These plans have been examined for compliance with the Ontario Building Code. This review has been completed subject to any changes noted, under the condition that the building will be constructed in accordance with the code.

Plan # 27M-47
Address: 234 ANTLER COURT
House model: RUTHERFORD 'A'
Lot coverage 8.4 %
Scale 1:250
Asphalt area 60.6 m²

LOT 31 SITE/GRADING PLAN
WHITE TAIL RIDGE PH. II

Re: Proposed Single Family Dwelling, 234 Antler Court, Lot # 31 White Tail Ridge, Arnprior, Kollaard Associates File # 210055

FOUNDATION PLAN
ELEVATION A

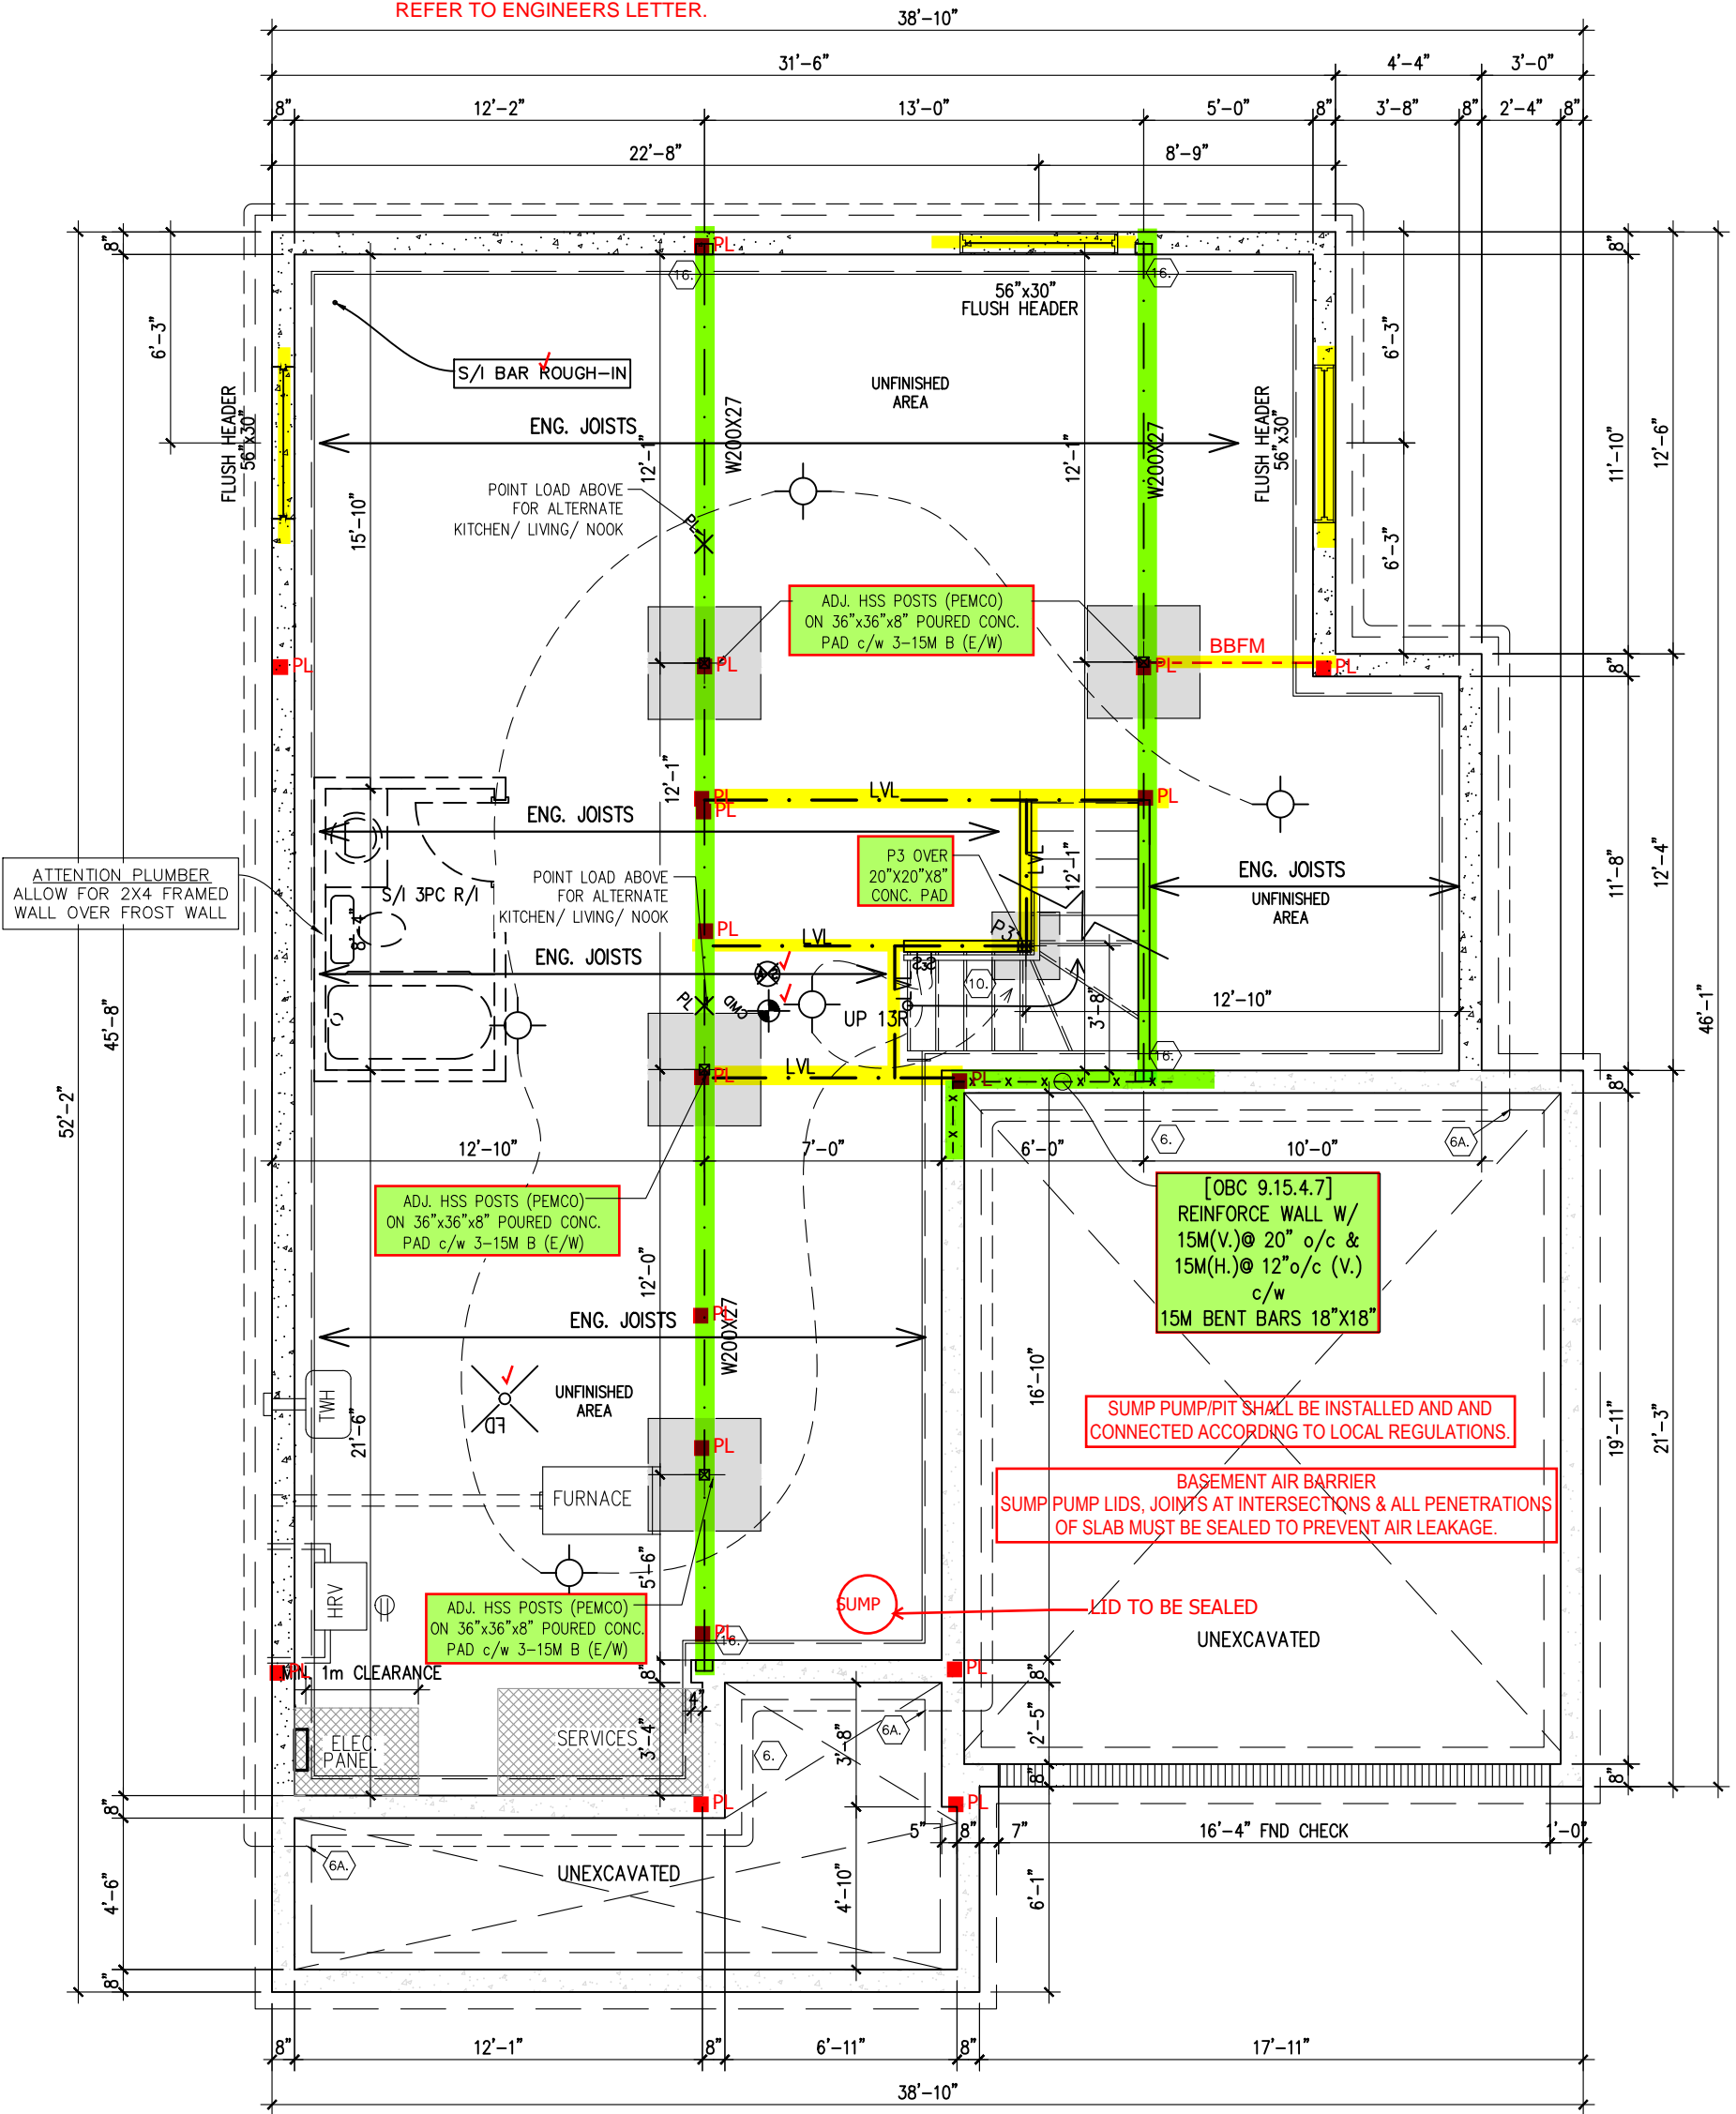
PROVIDE P.ENG APPROVED TRUSS & FLOOR
DRAWINGS AND SPECIFICATIONS TO BUILDING
INSPECTOR AT FRAMING INSPECTION

REINFORCING REQUIRED IN FOUNDATION WALLS,
FOOTINGS OR PORCH SLAB SHALL BE REVIEWED
PRIOR TO POURING CONCRETE (see inspector)

NON-LOADBEARING INTERIOR
WALLS IN UNFINISHED BASEMENTS
ARE NOT TO BE FRAMED

ALL STEEL BEAMS, STEEL POSTS, PORCH
SLAB REINFORCING, FOUNDATION WALLS &
FOOTINGS ARE REVIEWED BY ENGINEER,
REFER TO ENGINEERS LETTER.

REFER TO DETAIL SK-03 FOR WINDOW
OPENINGS > 47" TO < 56"

GROUND FLOOR PLAN
ELEVATION A

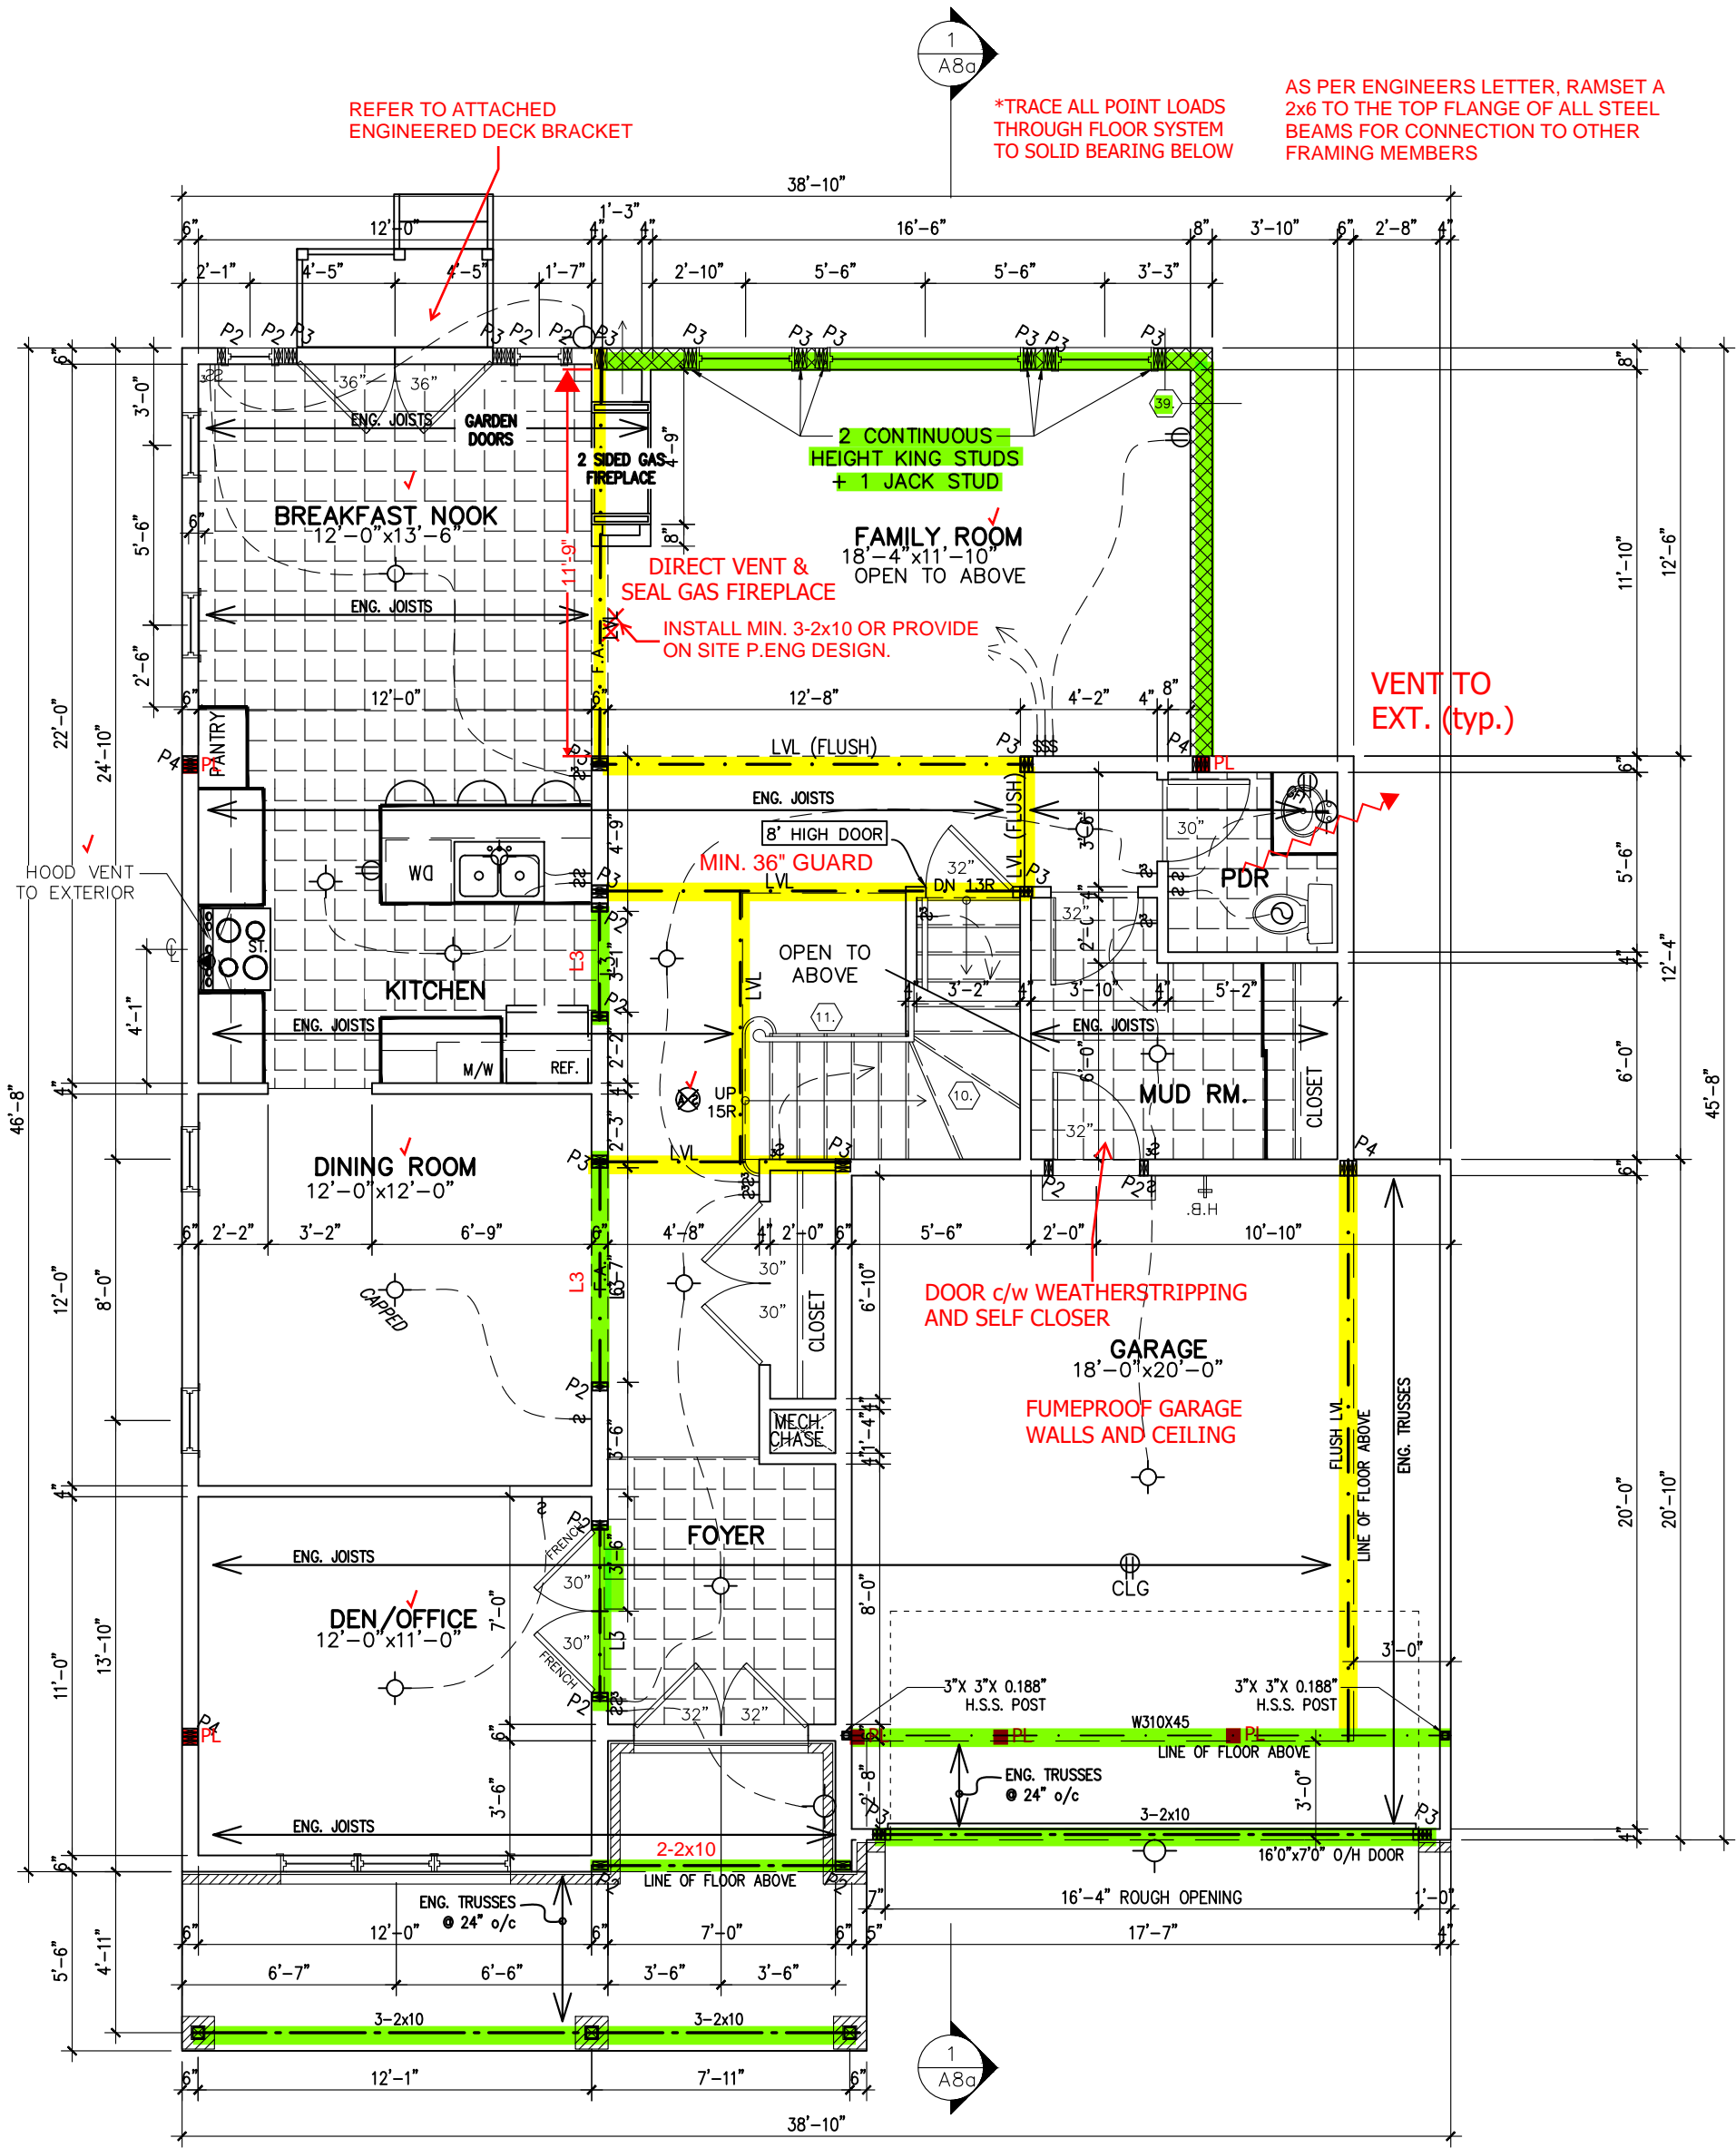
ALL PROPOSED TALL WALL, BEAMS, LINTELS AND SUPPORTING POSTS REVIEWED BY ENGINEER, REFER TO ENGINEERS LETTER.

FRONT ELEVATION A

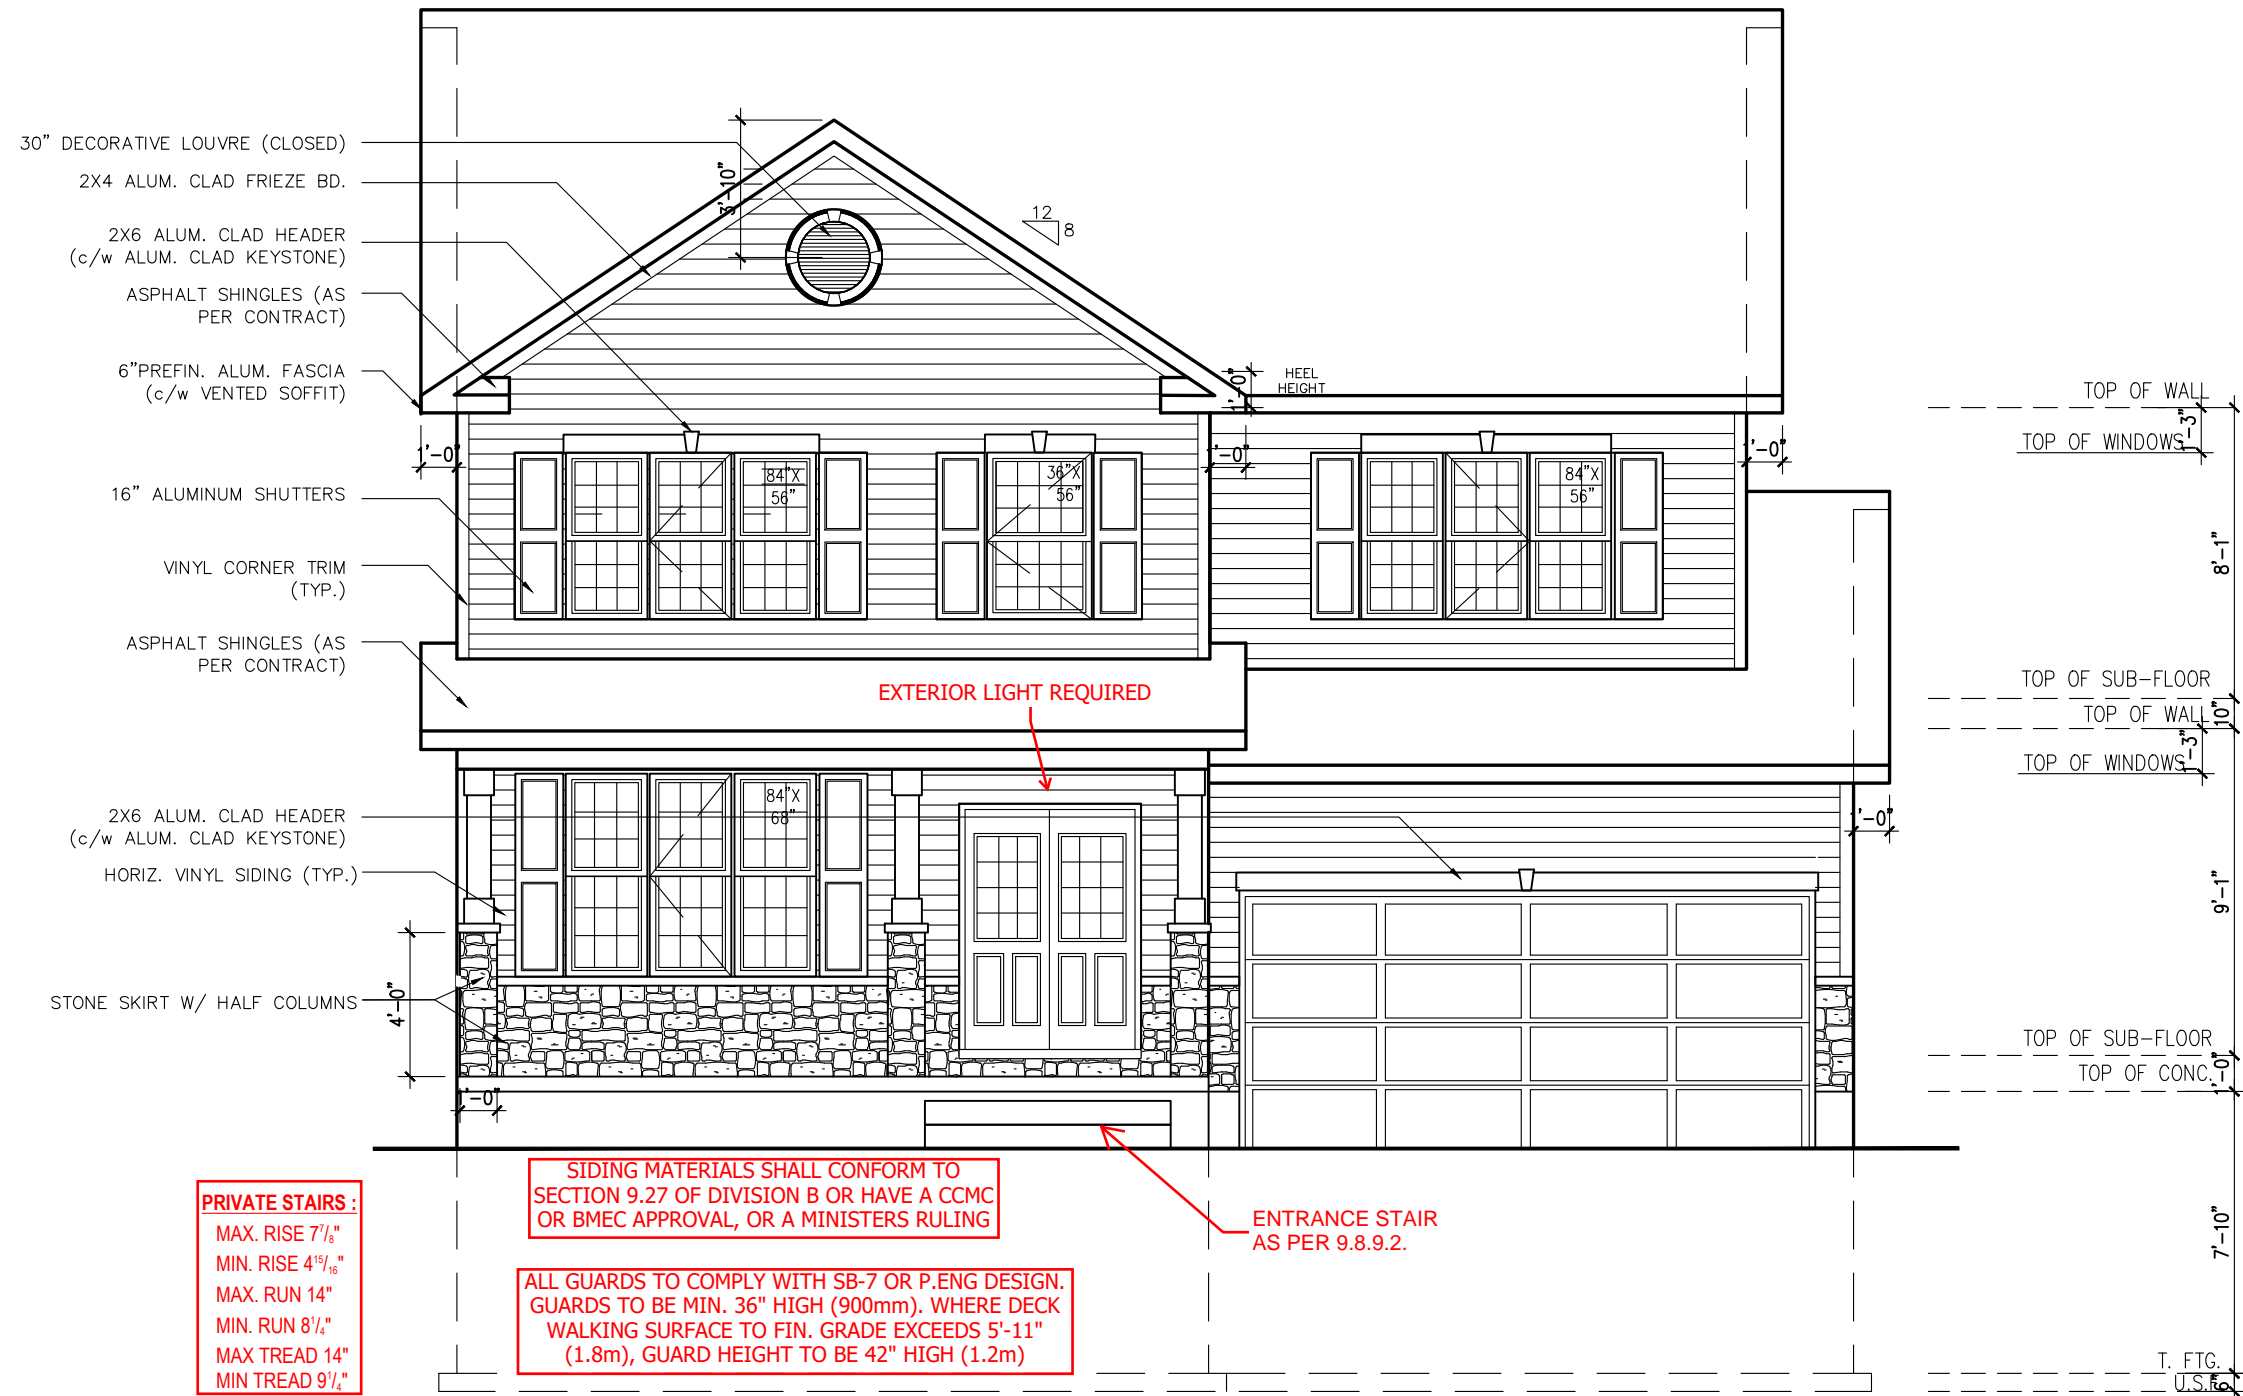
PROVIDE ENGINEERED CONNECTION
DETAILS AND RAILING MANUFACTURER
SPECS TO INSPECTOR ON SITE OR
INSTALL AS PER SB-7
